CUYAMA RIVER AGGREGATE MINING IMPACTS

INSTREAM-MINING - DIAMOND ROCK MINE

Robert R. Curry PhD Watershed Systems 11-1-11

Problem Statement for this report:

Fig 1 Appendix 3 from the 2010 Twitchell Management Authority report. Scale not accurate for this copy. See original at <http://www.ci.santa-maria.ca.us/3119-02.html>

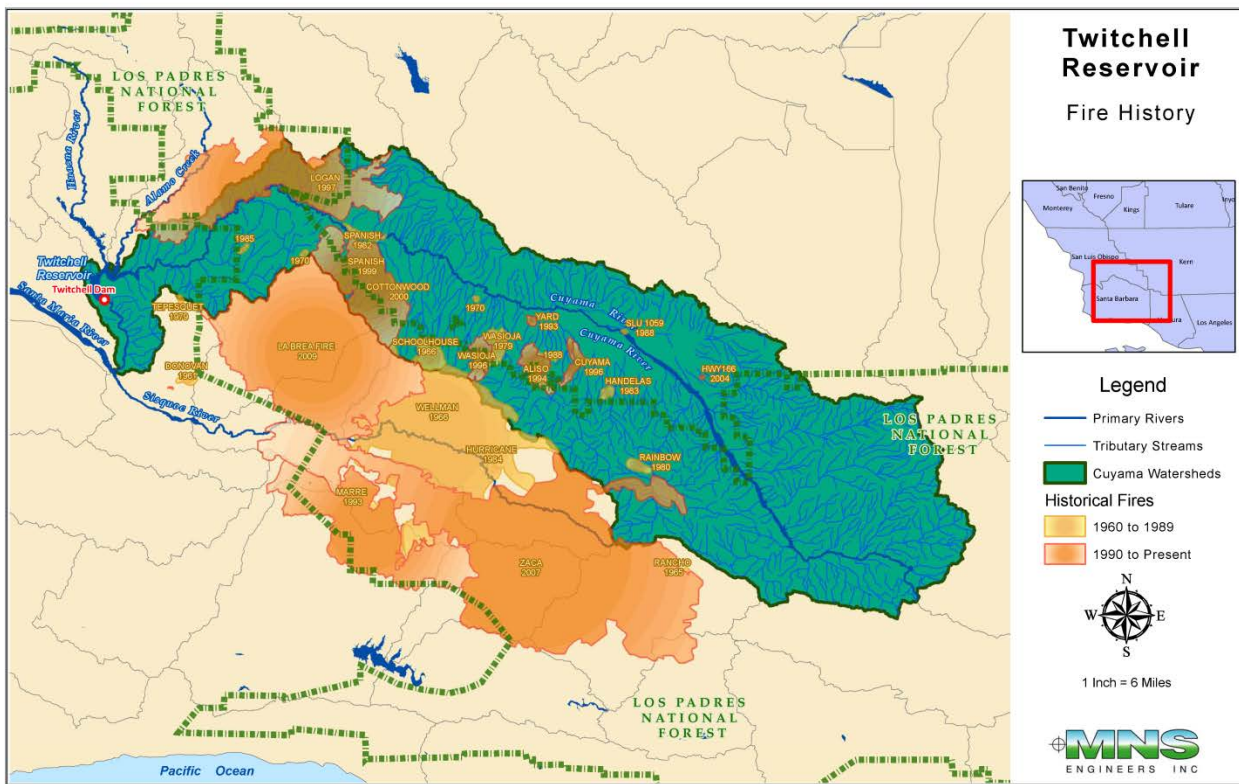
Estimating burn areas from the TMA fire map (Fig 1) for the Cuyama watershed of about 15,000 acres for the 1997 Logan fire, 3300 acres for the 2007 Zaca fire and comparing that to the NRCS 13,423 Cuyama watershed acres for the Brea fire, and applying their same sediment yield analyses proportionally to all the fires, we get a rough estimate of 250,000 cubic yards of fire related sediment yielded from about 50 square miles of burn areas if the Brea fire analyses are applied to all the fires areas equally. Because the 1997 Logan fire recovery coincided with the 1998 intense rainstorms, we may hypothetically propose 4 times the yield for that single event which would double the total yield for all fires to give a total estimate of 500,000 cubic yards. That is still much less than the annual accumulation of 2 million cubic yards that is implied by the filling of the reservoir. Fire alone is probably not the primary major source of Twitchell sediment.
